# HARNETT CENTRAL PRESS BOX

HARNETT CENTRAL PRESS BOX  
HARNETT COUNTY SCHOOLS  
2911 HARNETT CENTRAL RD, ANGIER, NC 27501

PROJECT INFORMATION:  
DATE: 1/10/2023  
DRAWN BY: RDH  
CHECKED BY: JEL  
SHEET TITLE  
COVER SHEET  
SHEET NUMBER  
G-001  
PROJECT# 21-11110

**BUILDING SECTIONS AND DETAILS**  
SHEET NUMBER  
**G-301**  
PROJECT# 21-11110

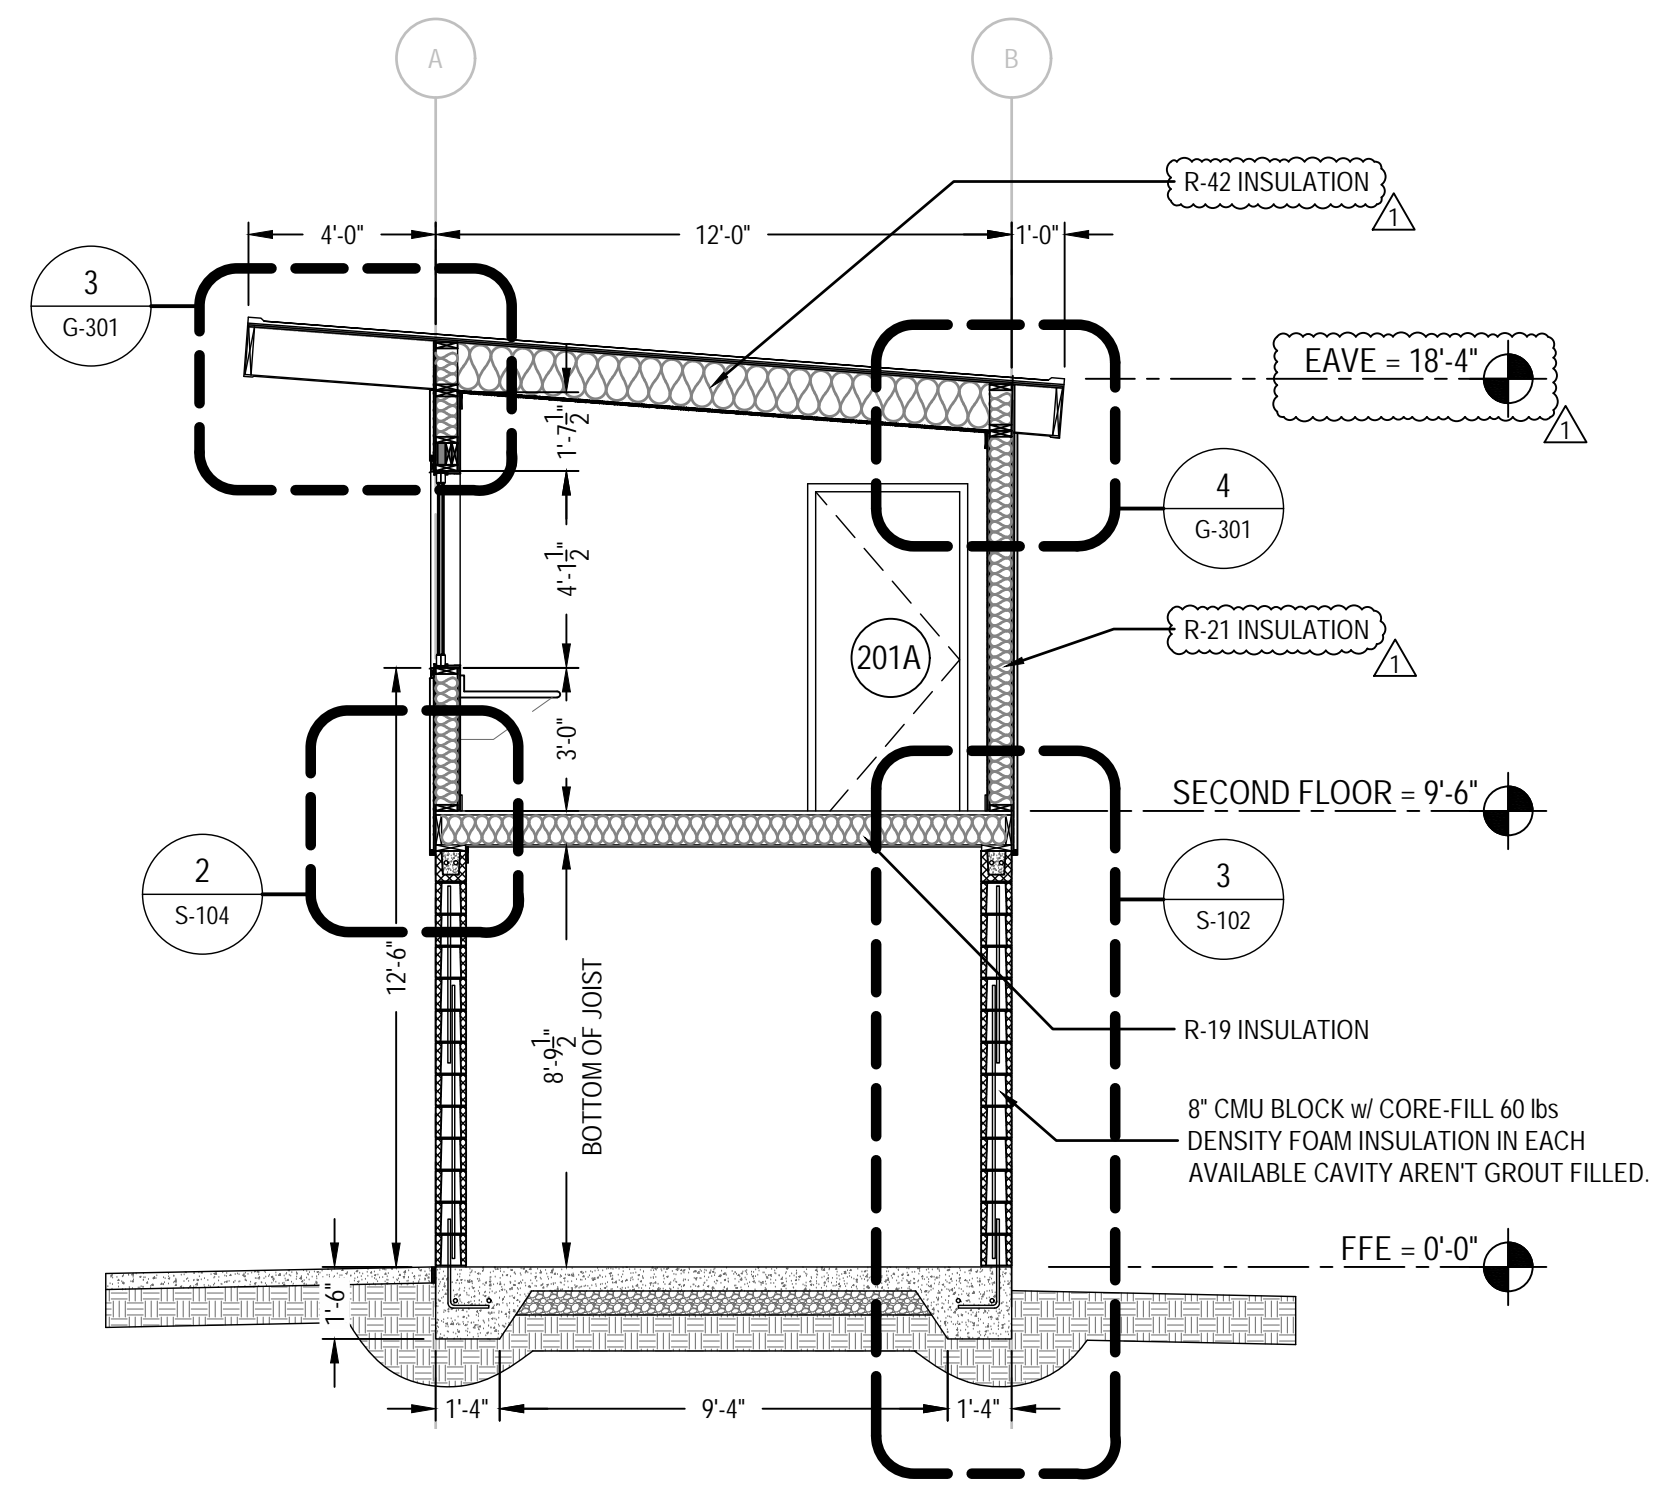
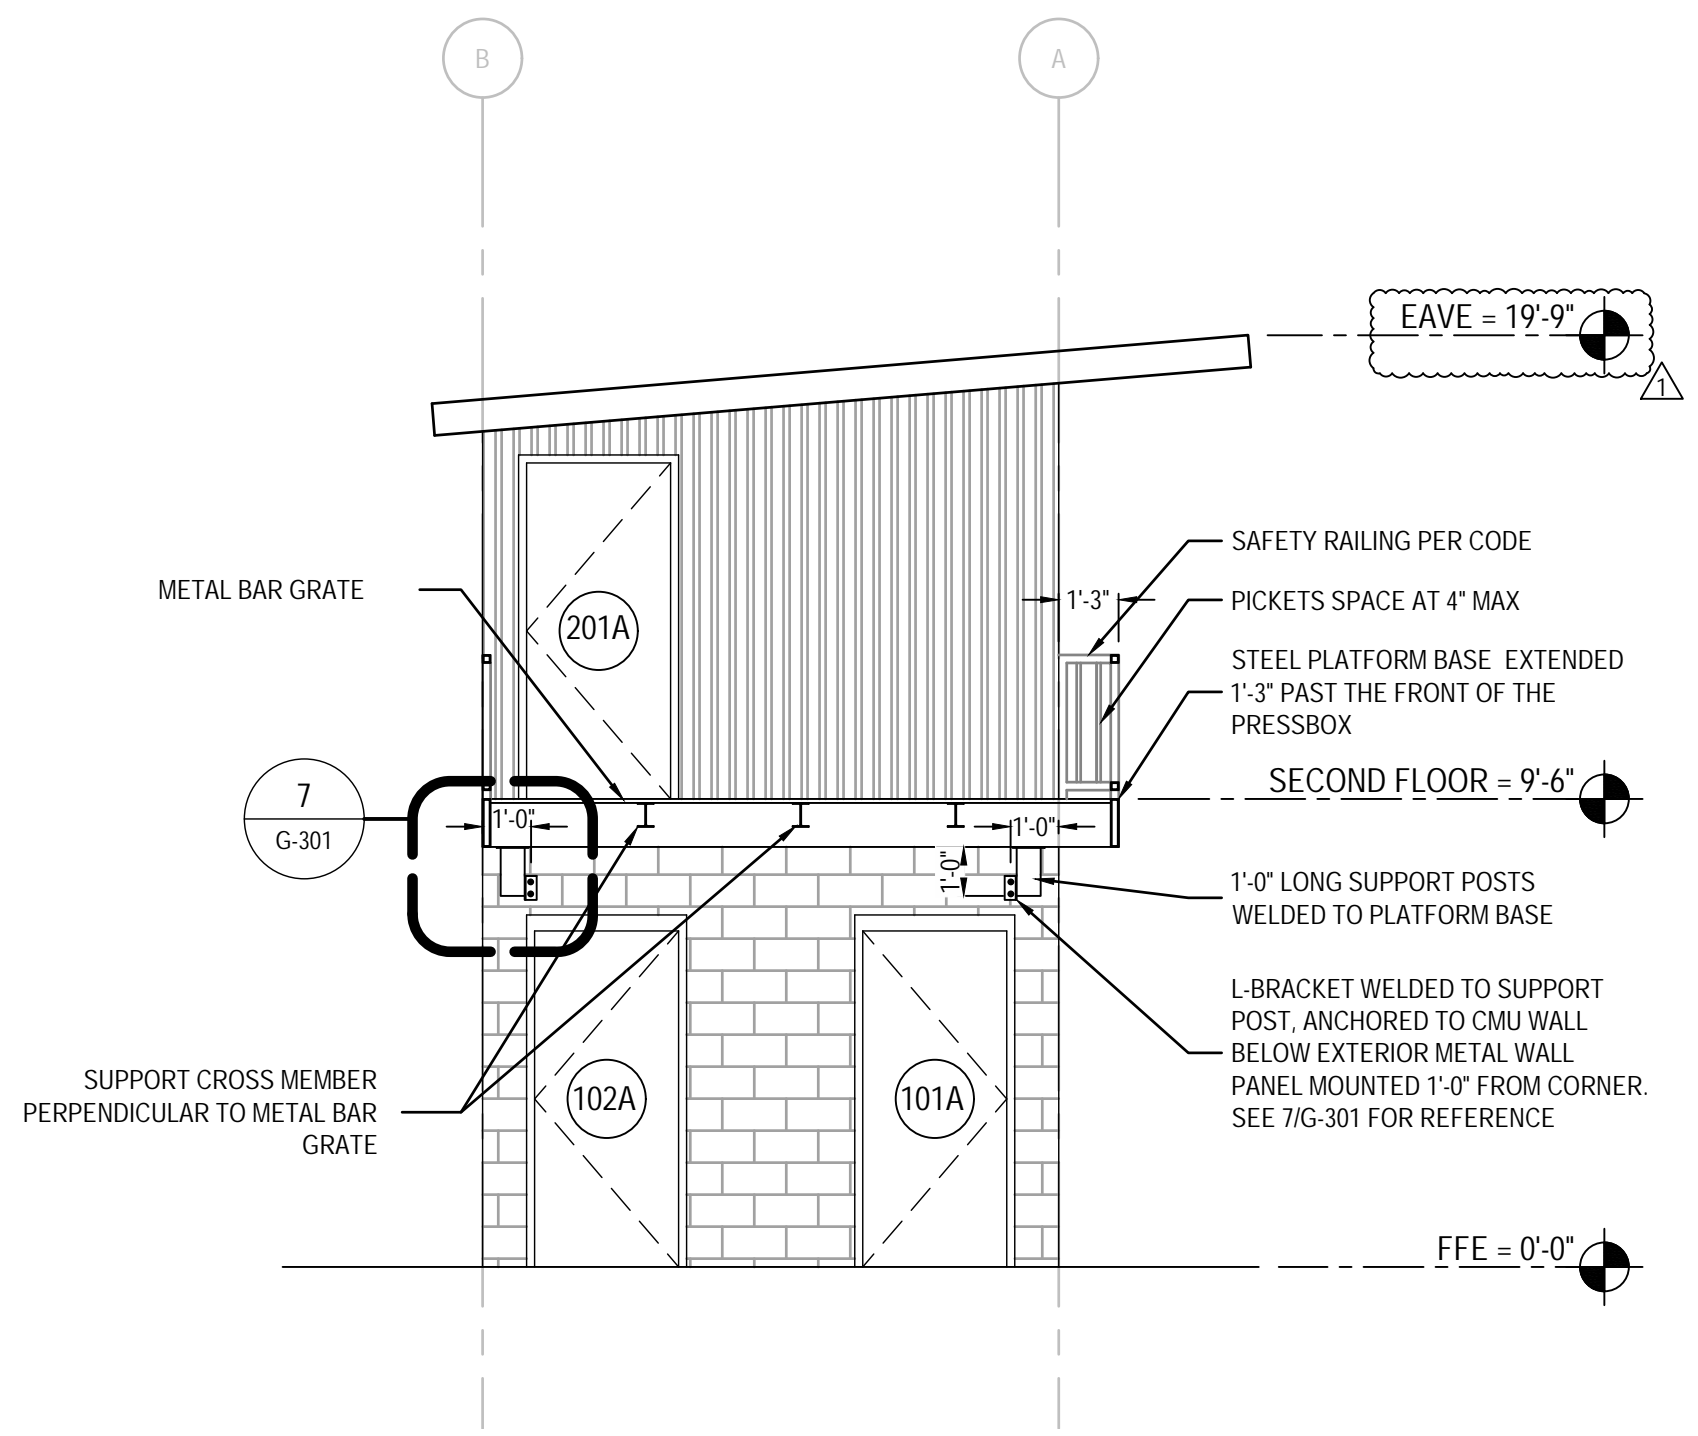
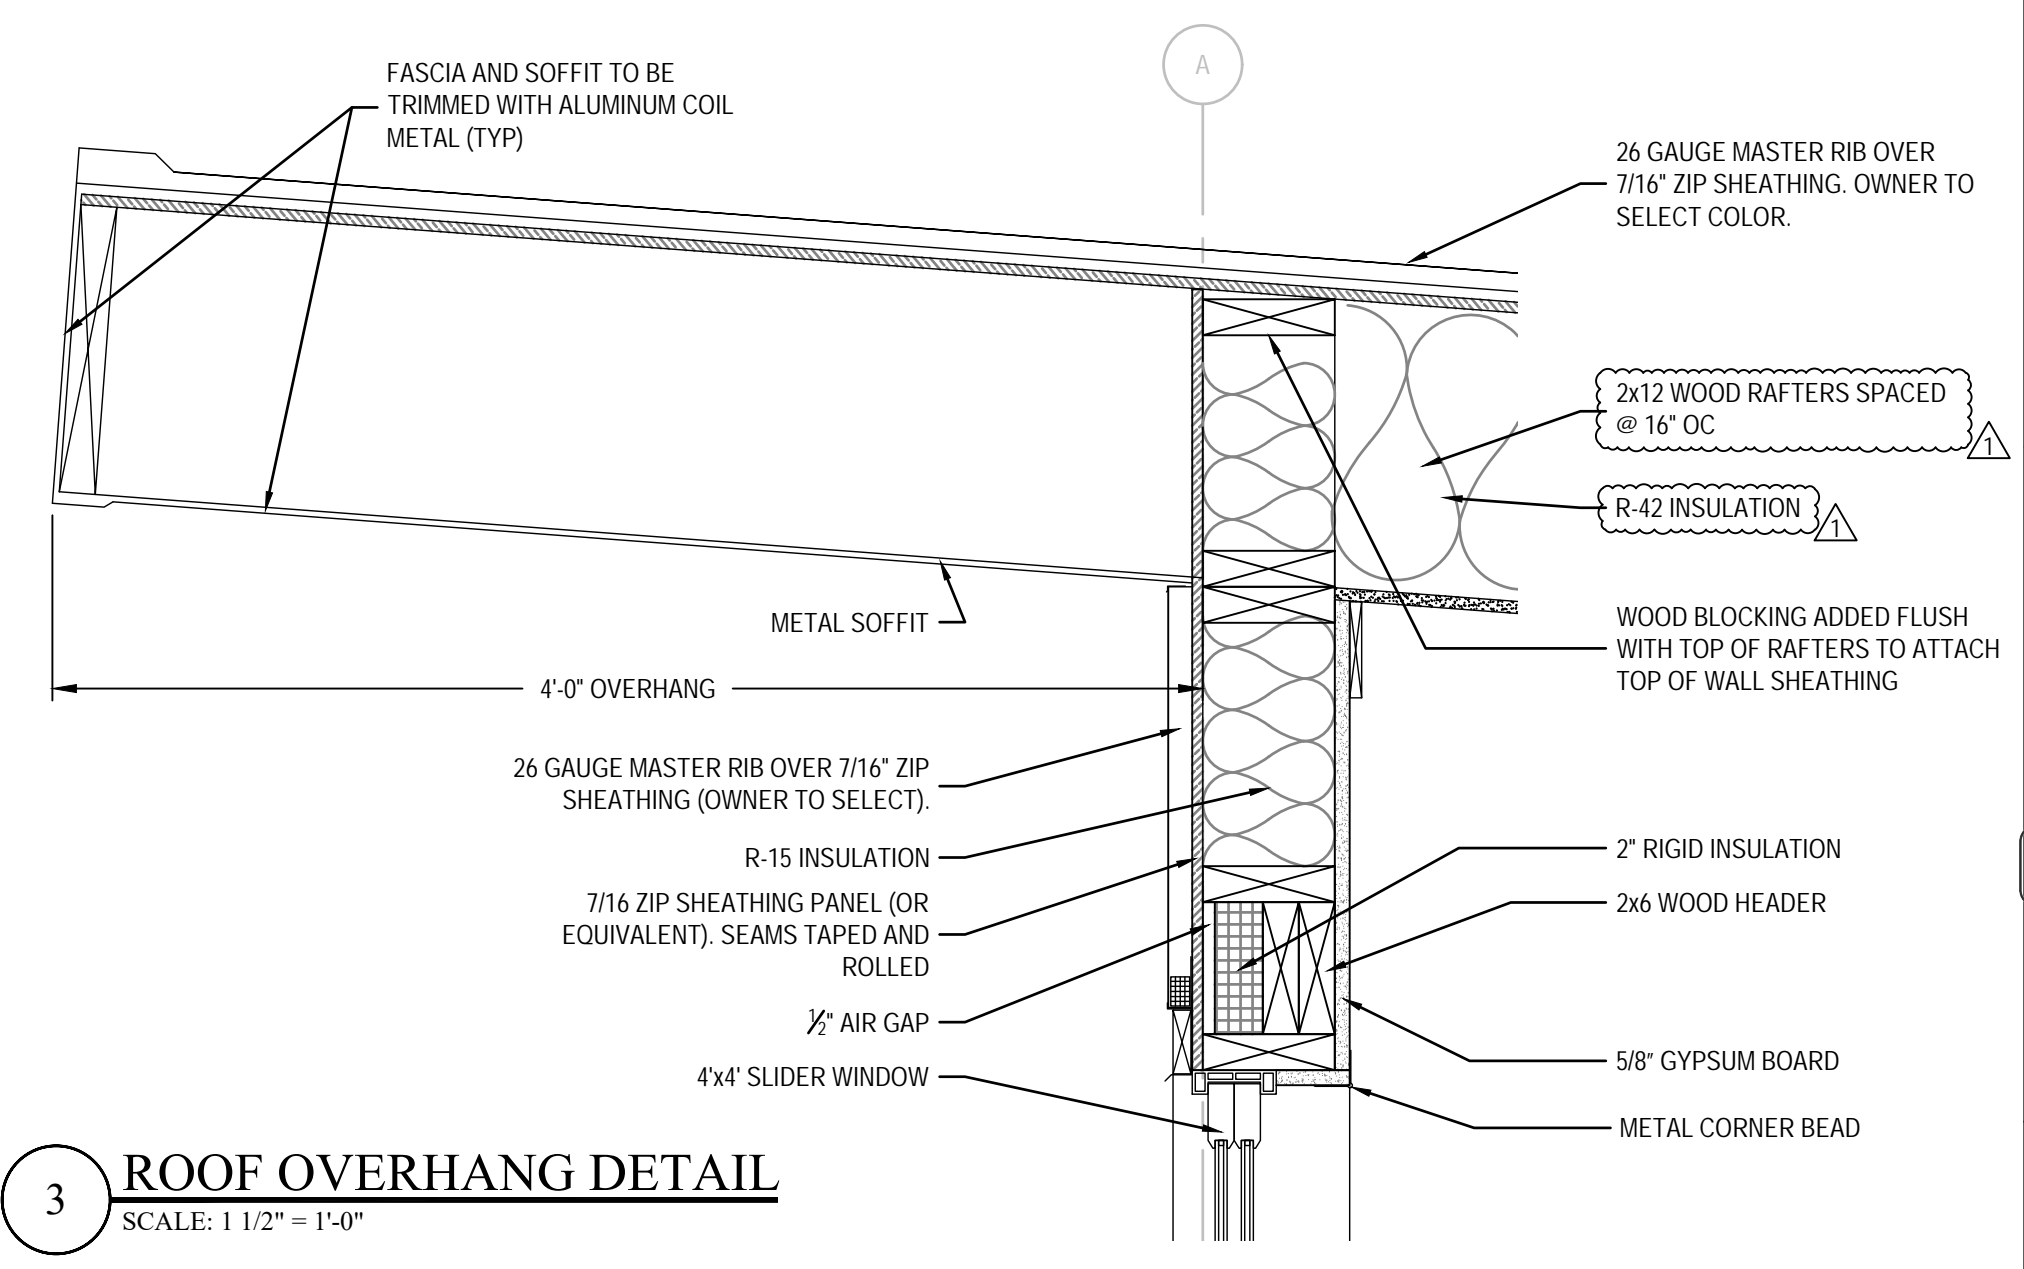
REVISION	DATE	DESCRIPTION
1	4/13/2023	ROOF RAFTERS AND INSULATION CHANGED; ELEVATIONS UPDATED.
2		
3		
4		
5
